RE: File No. 11239 – Rindge Commons Pre-K Interior Fit-Out - Addendum No. 2

Addendum No. 2

Rindge Commons Pre-K Interior Fit-Out

ADDENDUM # 2

Sheet Title
**ROOM FINISH
SCHEDULE AND
FLOOR PLANS**

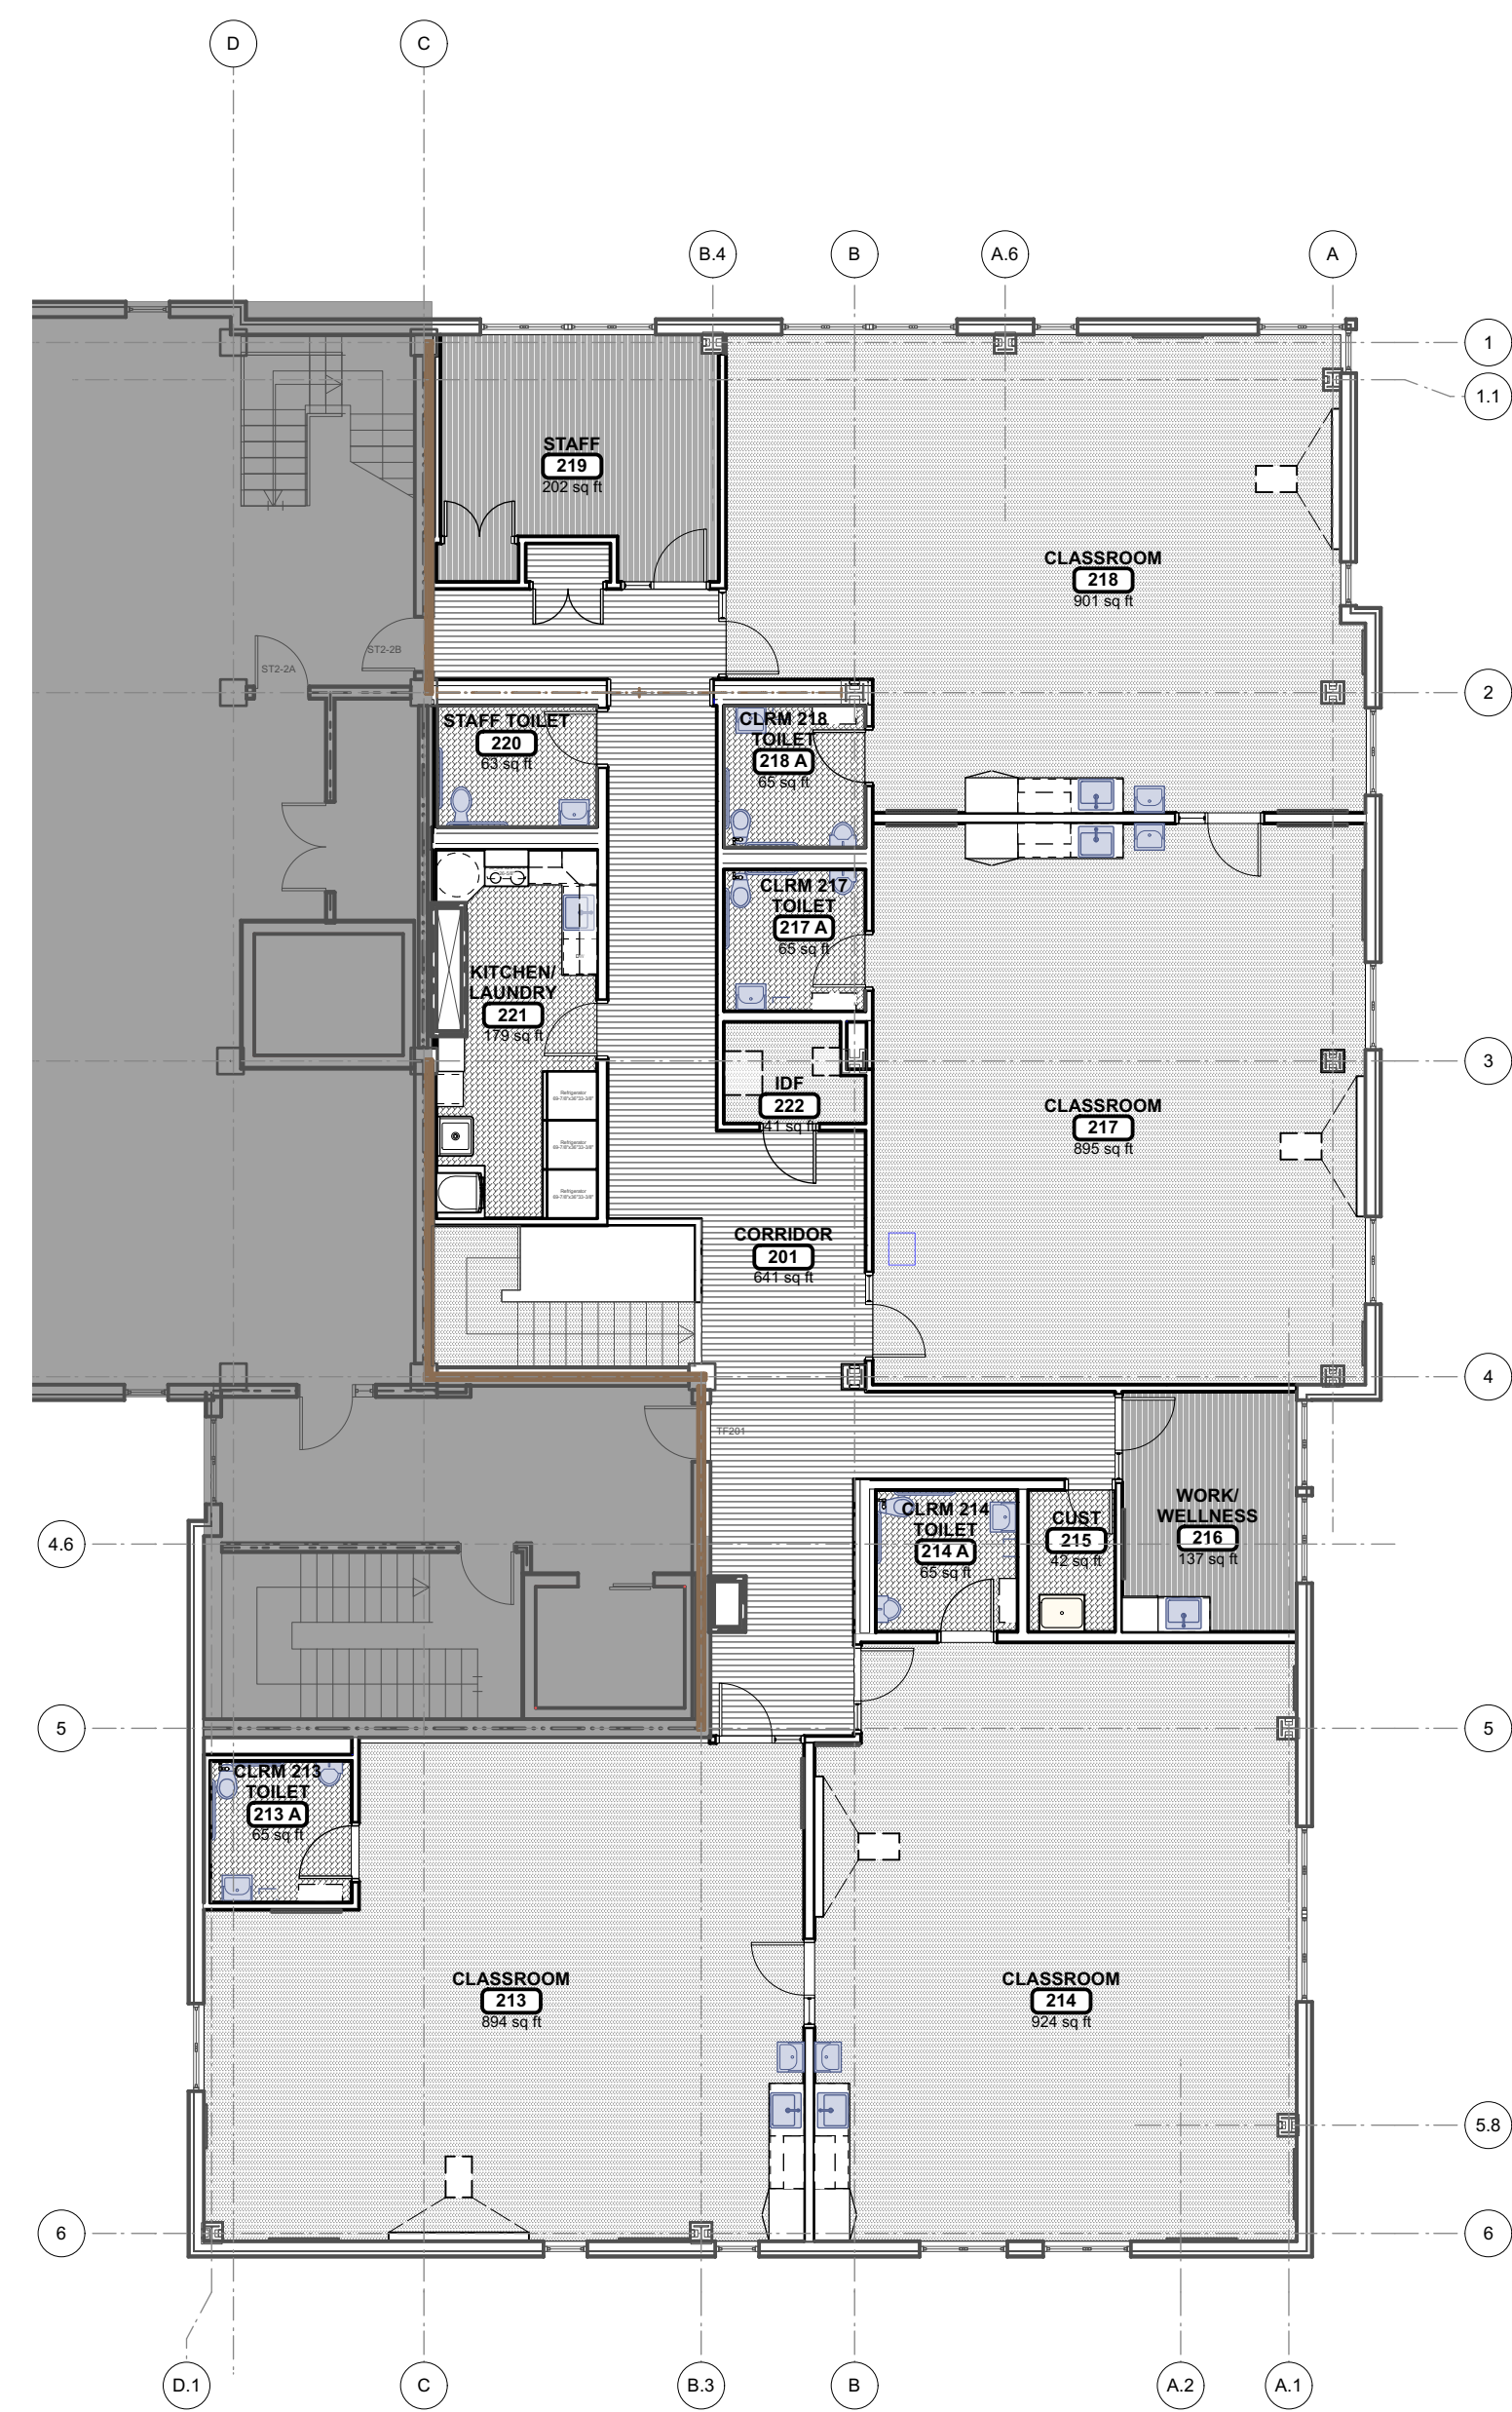
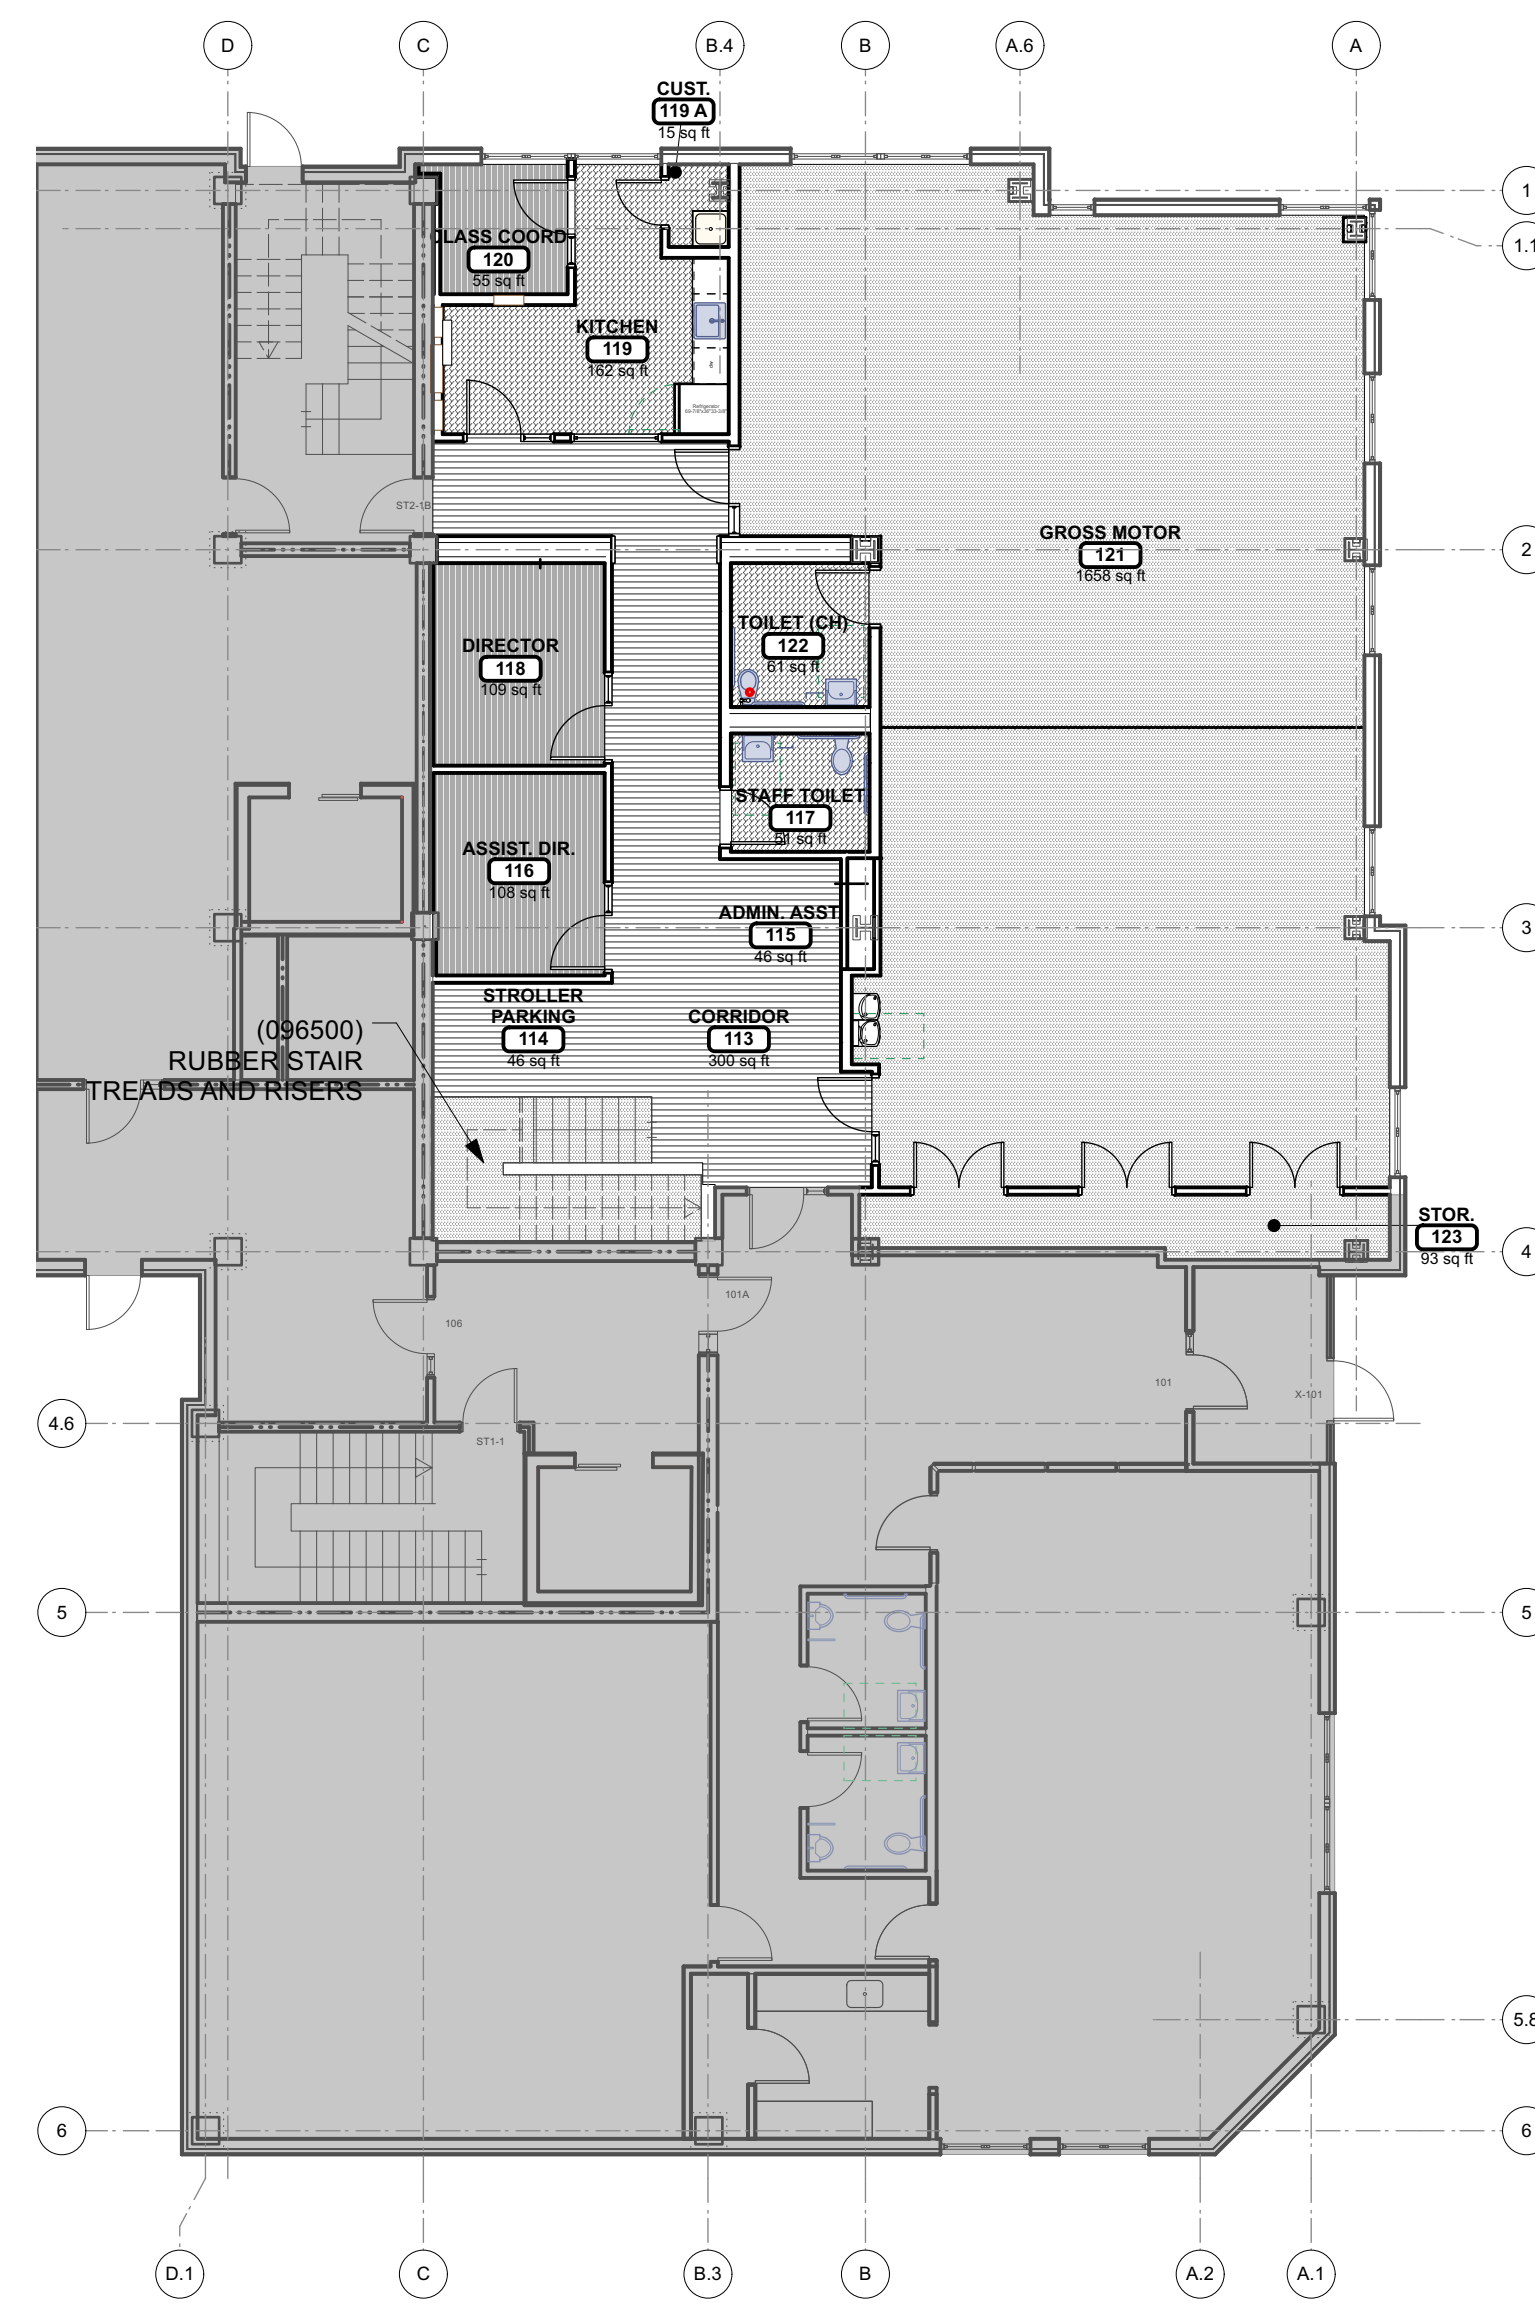
- **ITEM 2.13** Question: On drawing A8.2 Room Finish Schedule and Floor Plans the following rooms have a base finish indicated as Coved CT, 117 Staff Toilet, 122 Toilet (CH), 213A CLRM 213 Toilet, 214A CLRM 214 Toilet, 217A CLRM 217 Toilet, 218A CLRM 218 Toilet, and 220 Staff Toilet. The toilet room elevations on drawing A7.1 have the base in these toilet rooms as (096700) Epoxy Cove Base, which matches the Epoxy Floor in these toilet rooms. Please clarify if the base in these toilet rooms is Coved CT to match the CT wall or (096700) Epoxy Cove Base to match the Epoxy Floor?

- **ITEM 2.15** Question: On drawing A8.2 Room Finish Schedule and Floor Plans the following room, 215 Custodian is scheduled to receive Coved CT base, and CT walls on all walls. Room 119A Custodian has Epoxy Floor, Coved Epoxy, and Epoxy Painted walls. The room elevations on A6.3, elevations 21A, 21B, 21C, and 21D indicate Epoxy Cove Base and P-Lam Walls. Please clarify if room 215 Custodian requires Coved CT base and CT walls?

Response: Toilet Rooms should have Epoxy Floor with Integral Coved Epoxy Base (by 096700),
- **ITEM 2.14** Question: If the base in the toilet rooms listed in question 1 is Epoxy Cove Base, will a metal cap trim piece be required at the top of the of the 4" Epoxy Cove Base and who will be responsible for said metal cap trim. Please clarify if metal cap trim is required at said base and who is responsible for this metal trim?

Response: Custodian Rooms 119A and 215 should have Epoxy Floor with Integral Coved Epoxy Base (by 096700), and P-Lam Walls.
- **ITEM 2.16** Question: Is a completing Temporary Heating Plan and System required? (Ref. 015000 1.01 G and 1.04 C)
